CLAY SUBDIVISION

APPLICATION NUMBER 10 DATE May 5, 2005
APPLICANT Clay Subdivision
REQUEST Subdivision

DETAIL SITE PLAN

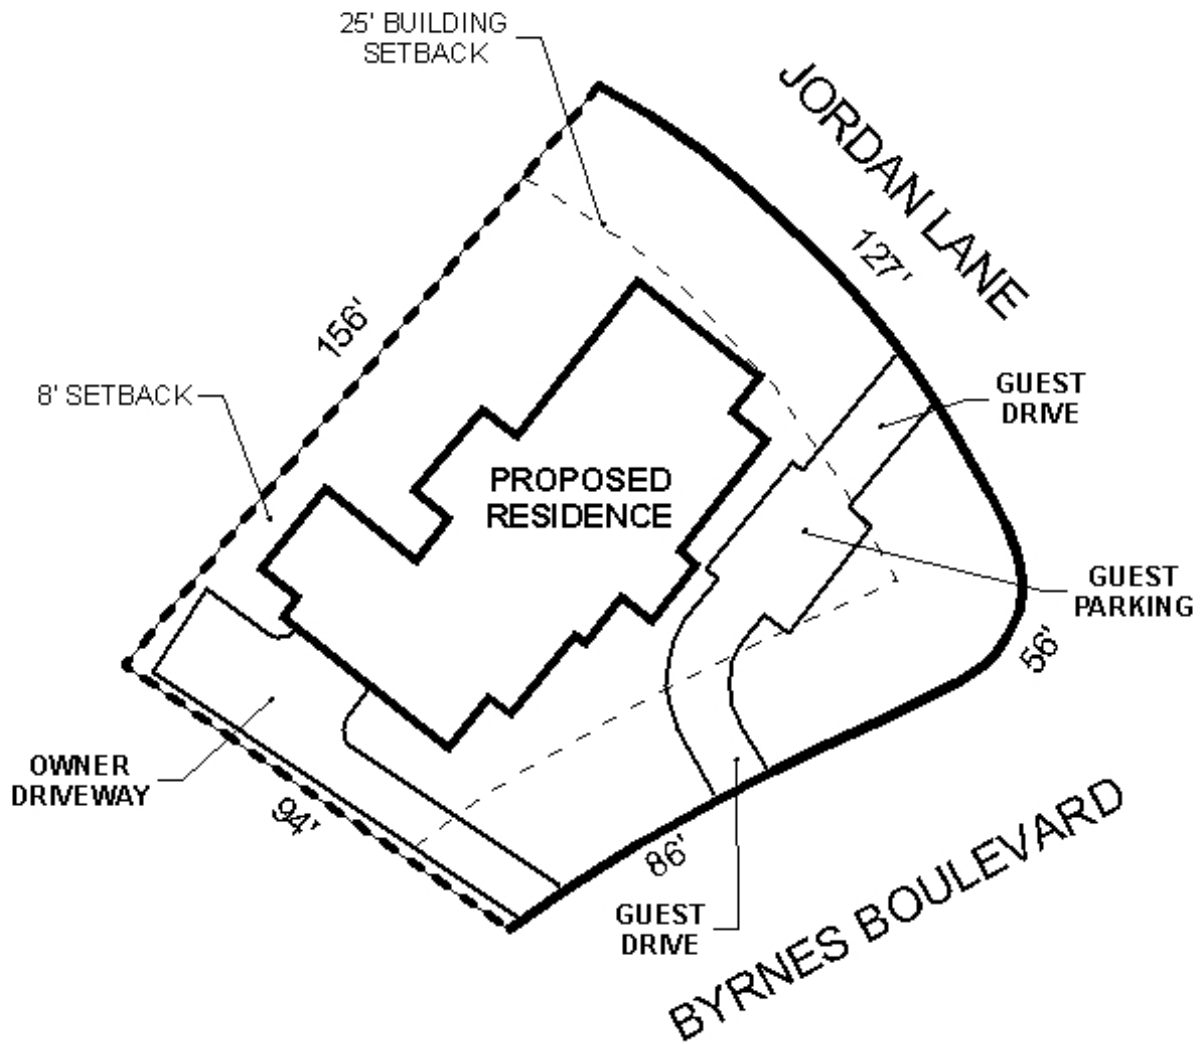
The purpose of the application is to resubdivide a lot, to remove the one-curb restriction on the record plat, to allow three curb cuts.

The site is a corner lot that fronts Byrnes Boulevard, which has a 60' right-of-way, and Jordan Lane, which has a 50' right-of-way.

The Planning Commission granted subdivision approval to the site in 2004, with the condition that the lot was limited to one curb cut. As this is new construction still in the design phase, the development could be redesigned to address the applicant's needs with fewer than three curb cuts.

Increasing the number of allowed curb cuts would result in increased traffic conflict at the intersection of Byrnes Boulevard and Jordan Lane, and would contribute to increased run-off associated with impervious surfaces.

Based on the preceding, the plat is recommended for denial.
